**GEOLOGIC HAZARD EVALUATION AND
PRELIMINARY GEOTECHNICAL INVESTIGATION
GRANDVIEW RESERVE, FILING 1
EASTONVILLE ROAD AND U.S. HIGHWAY 24
FALCON, COLORADO**

See comments within report, the ECM requires geologic hazards and geotechnical reports addressing site constraints and mitigation for projects involving construction of public improvements. The DCM Volume 1 addresses the need for geotechnical analyses for embankment structures and DCM Volume 2 addresses geotechnical construction requirements for water quality best management practices (BMPs). Applicants are also required to comply with the State Engineer's requirements regarding embankments and dams utilized for storage of water.

FIG. 1 – LOCATIONS OF EXPLORATORY BORINGS

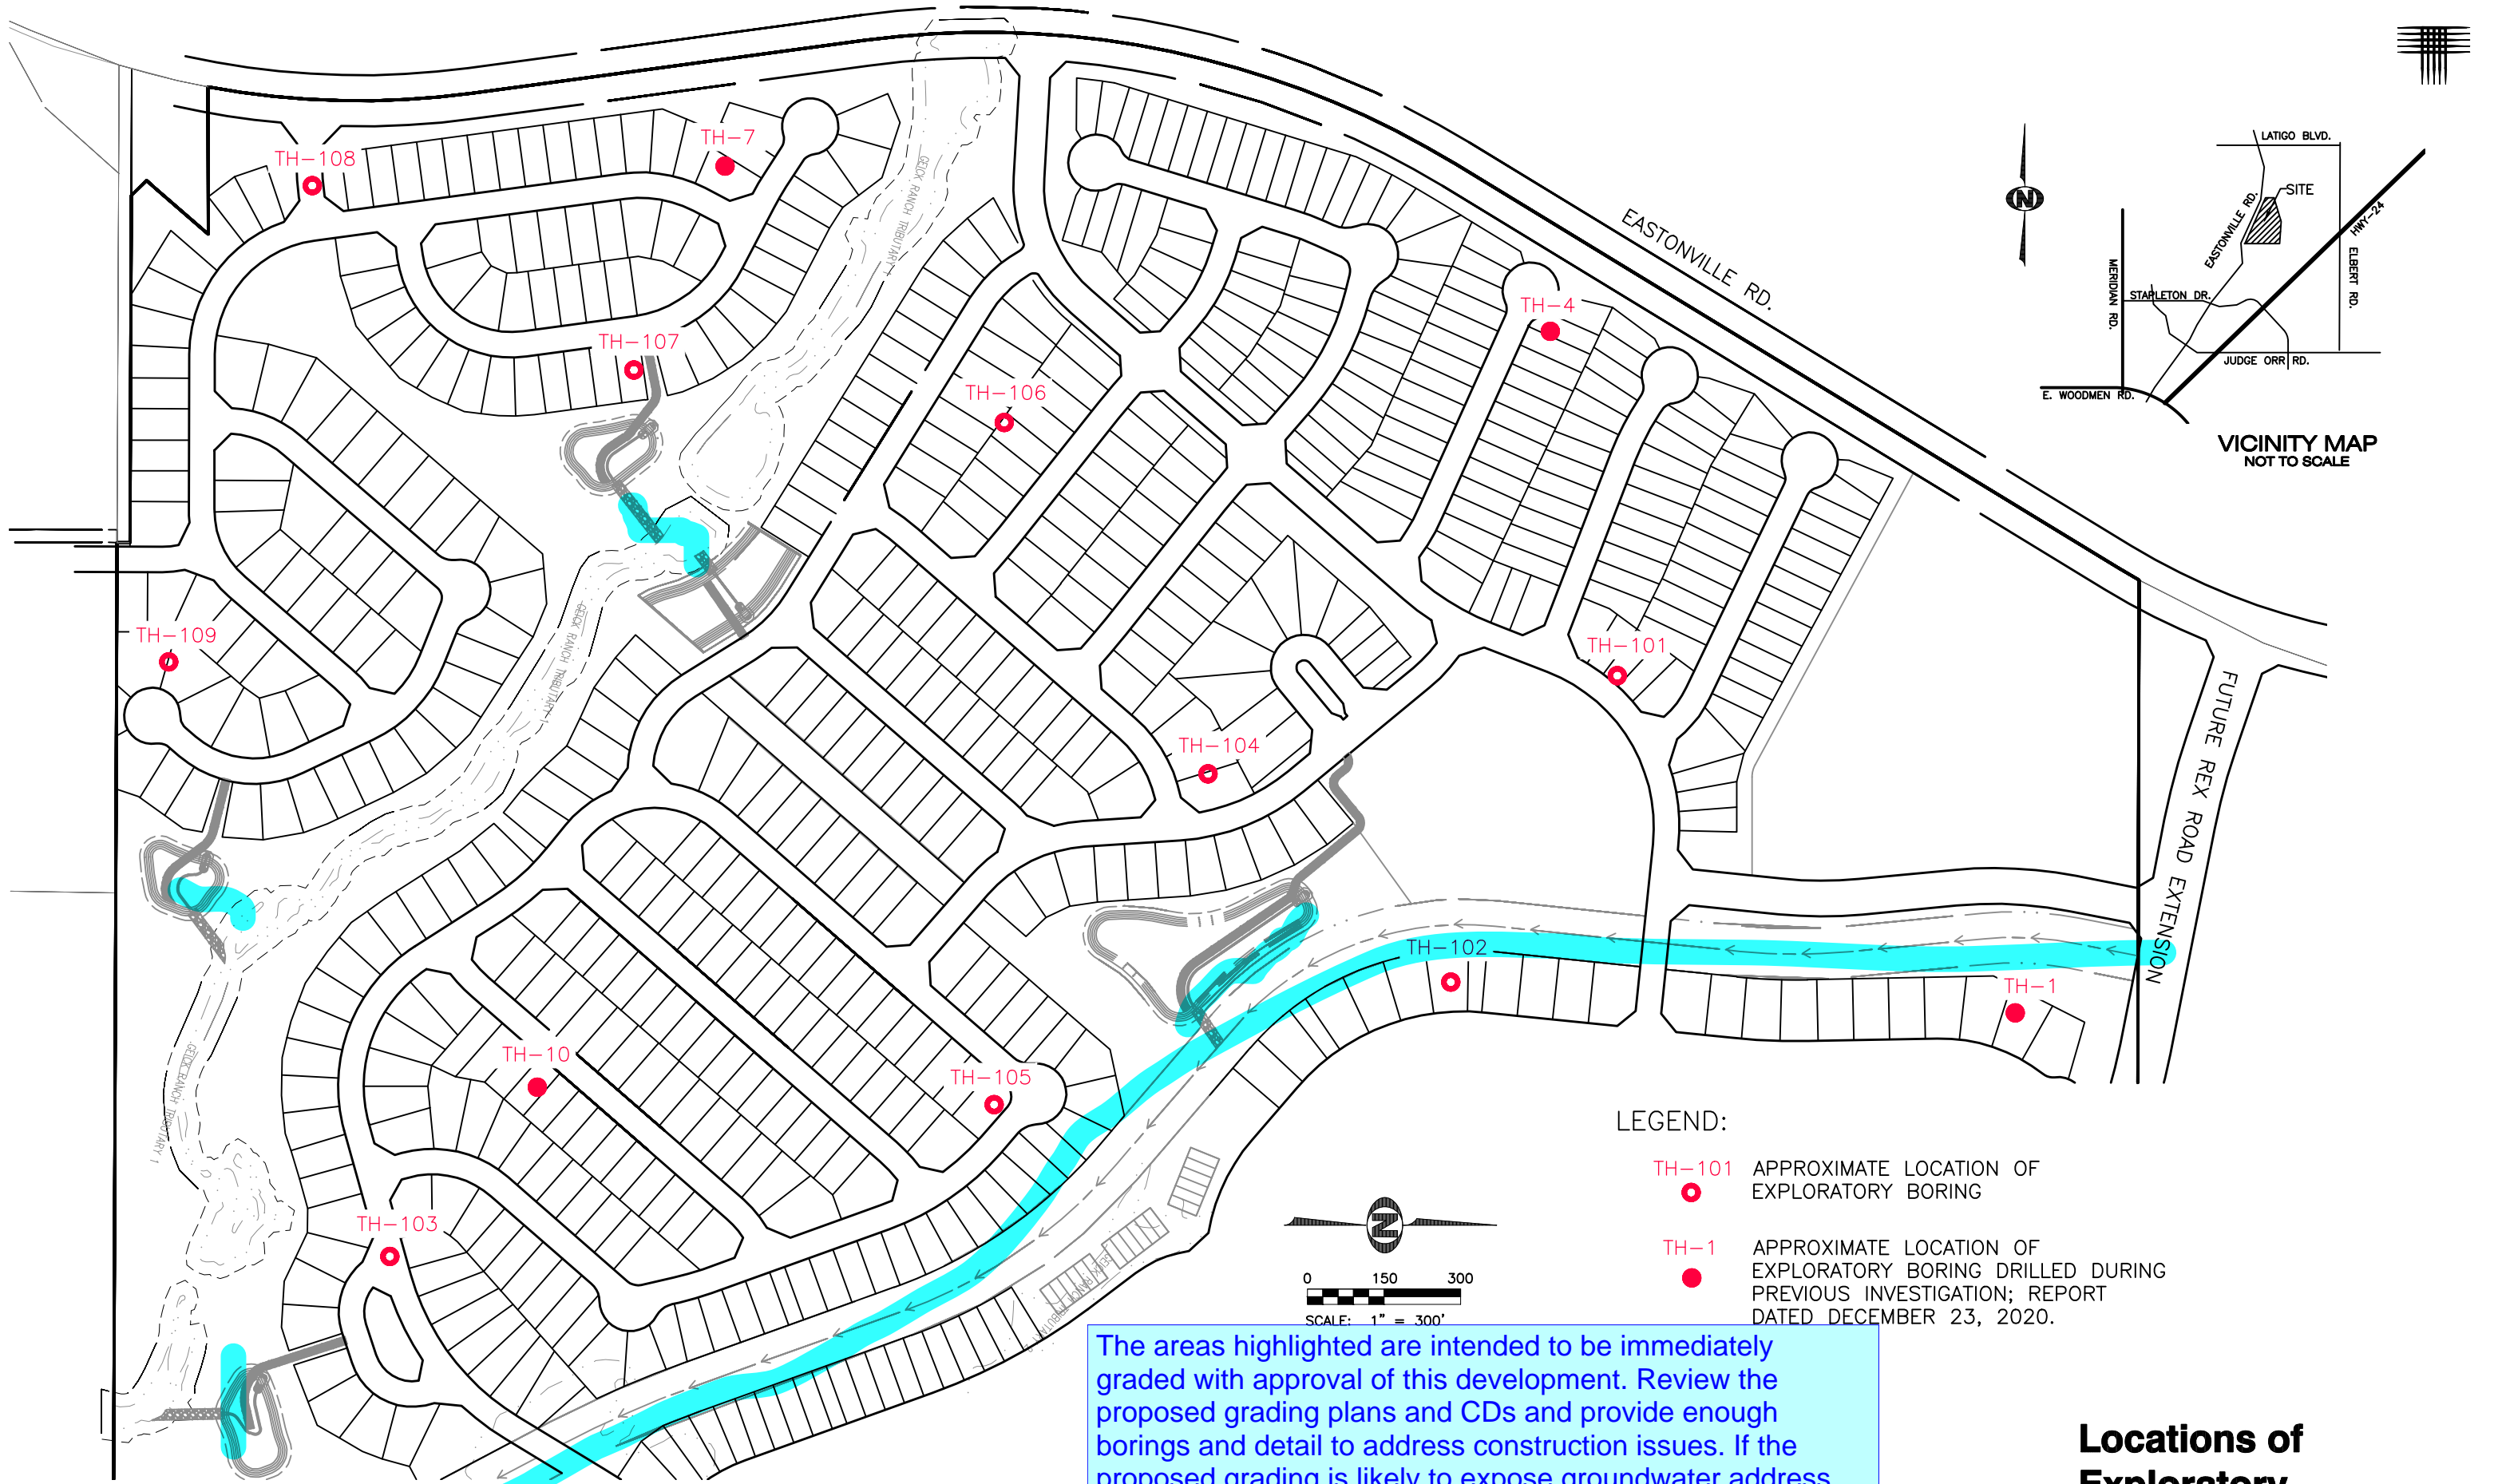
The areas highlighted are intended to be immediately graded with approval of this development. Review the proposed grading plans and CDs and provide enough borings and detail to address construction issues. If the proposed grading is likely to expose groundwater address mitigation measures.

FIG. 2 – ENGINEERING GEOLOGIC CONDITIONS

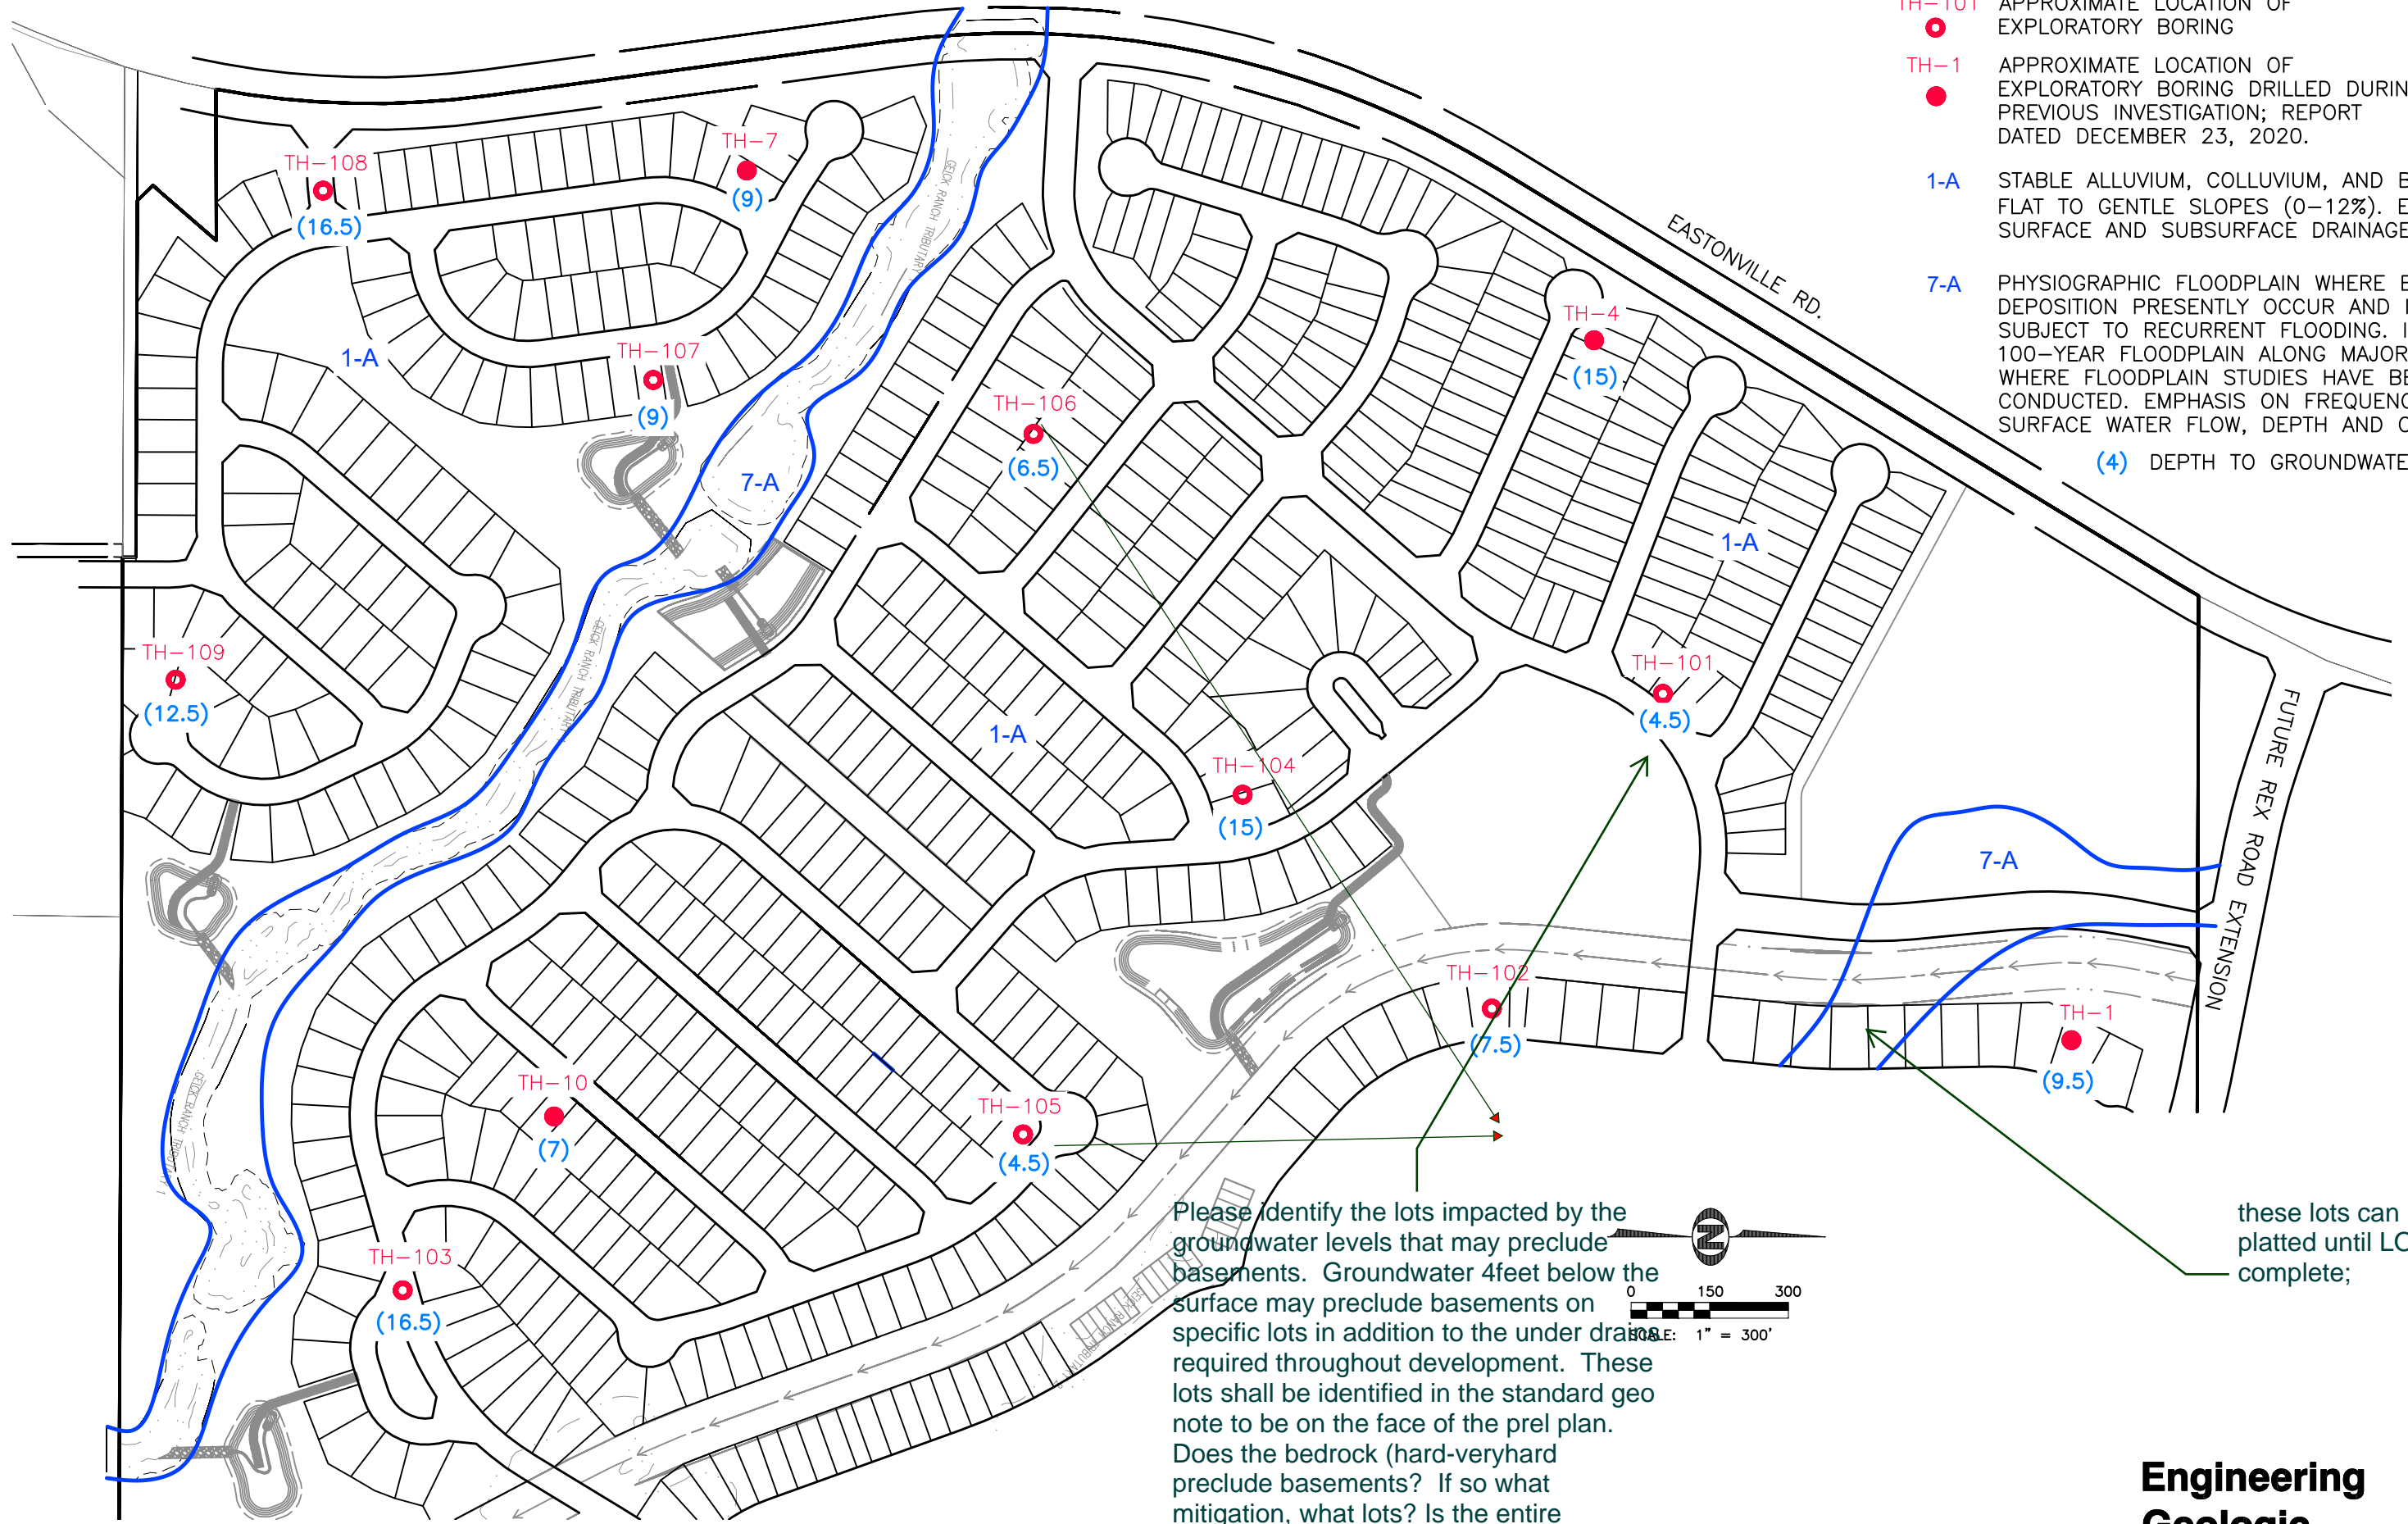
Please identify the lots impacted by the groundwater levels that may preclude basements. Groundwater 4feet below the surface may preclude basements on specific lots in addition to the under drains required throughout development. These lots shall be identified in the standard geo note to be on the face of the prel plan. Does the bedrock (hard-veryhard preclude basements? If so what mitigation, what lots? Is the entire development subject to heave or just some lots? Please clarify graphicly and via Geo note on prelim plan
